Stellaris[®] LM3S1816 RevB1 Errata

This document contains known errata at the time of publication for the Stellaris[®] LM3S1816 microcontroller. The table below summarizes the errata and lists the affected revisions. See the data sheet for more details.

Figure 1. Workaround Circuit to Ensure Initial Power Up

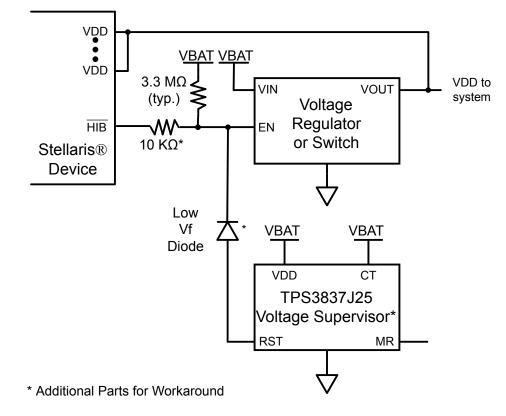
If V_{DD} is not powered when voltage is first applied to V_{BAT} , the state of the Hibernation module is indeterminate and the $\overline{\text{HIB}}$ signal may be asserted. In this indeterminate state, a lock condition can occur in which the Hibernation module waits for a power-on-reset, but that reset cannot occur until the module deasserts $\overline{\text{HIB}}$. This issue is related to the errata "Hibernation module may have higher current draw than specified in data sheet under certain conditions" on page 5.

The workaround implementation depends on the system-level power supply configuration. For systems that use a battery as the primary power source, an external voltage supervisor (TPS383J25DBV or similar) circuit can be added to force the V_{DD} power supply to start when the battery voltage is first applied (see Figure 1). The voltage supervisor requires only 220 nA and generates a 200-ms positive pulse to turn on the V_{DD} regulator and activate the microcontoller's internal POR circuit.

Figure 2. Configuration of External Regulator

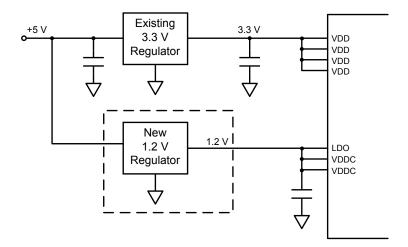
Incorrect power sequencing during power up can disrupt operation and potentially cause device failure.

V_{DDC} must be applied approximately 50 µs before V_{DD} . Normally V_{DDC} is controlled by the part's internal LDO voltage regulator. The workaround requires the addition of an external regulator (see Figure 2) to ensure that V_{DDC} sequencing requirements are met (see Figure 3). Recommended regulators include FAN1112SX (SOT223) and FAN2558S12X (SOT23-5).

This fix mitigates the on-chip power issue, but does not solve it completely. During development, the Flash memory should also be reprogrammed (using LMflash or another programming tool) at least once a week.
